CF34-8E ALERT SERVICE BULLETIN - 72- A0115 R03
Revised:  
12/09/2016SB 72-A0115 R03 ENGINE - FAN ROTOR ASSEMBLY (72-21-00) -  
INTRODUCTION OF FAN BLADE BUSHING REPAIRIssued:  
11/05/2010**GE PROPRIETARY INFORMATION**

TRANSMITTAL INFORMATIONREVISION 3 TO SERVICE BULLETIN 72-0115

This Service Bulletin introduces a fan blade bushing repair by a controlled cold expansion process, approved by GE Aviation, that extends the allowable fan blade operation by an additional 28,000 engine cycles from the time of the repair.

Fan Blade Location  
Figure 1

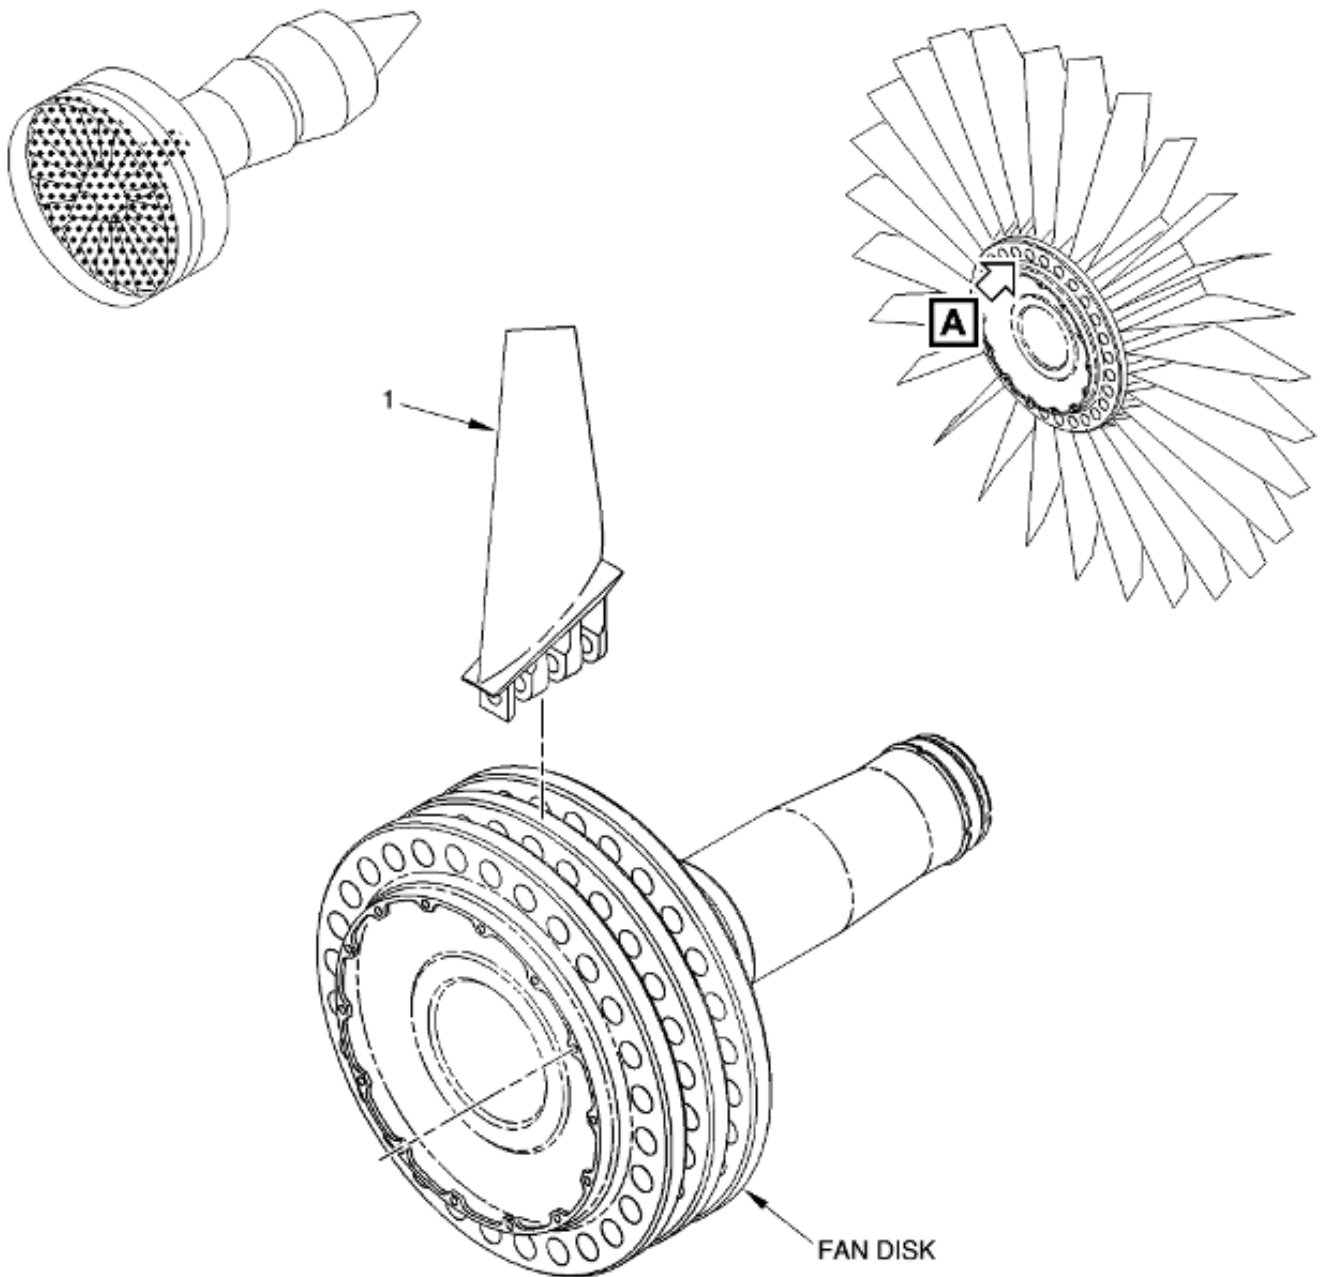
- (1) Remove the affected fan blades (1, Figure 1). Refer to GEK 112031, 72-00-21, REMOVAL.
- (2) Send the removed fan blades (1, Figure 1) to an approved repaired source to be reworked per RD 830-623. Refer to the APPROVAL OF REWORK SOURCES NOTICE below for contact information.

- (3) Install the reworked fan blades (1, Figure 1). Refer to GEK 112031, 72-00-21, INSTALLATION.
- (4) After you comply with this Service Bulletin, do as follows:
  - (a) Once the reworked fan blades (1, Figure 1) reach 28,000 engine cycles since fan blade bushing repair, replace it as follows:
    - 1 Remove the affected reworked fan blades (1, Figure 1). Refer to GEK 112031, 72-00-21, REMOVAL.
    - 2 Discard the removed reworked fan blades (1, Figure 1).
    - 3 Install new fan blades (1) of the same part number (P/N 4114T15P02). Refer to GEK 112031, 72-00-21, INSTALLATION.

**LEGEND:**  
1. FAN BLADE  
REPLACE OLD PART WITH  
P/N 4114T31G01
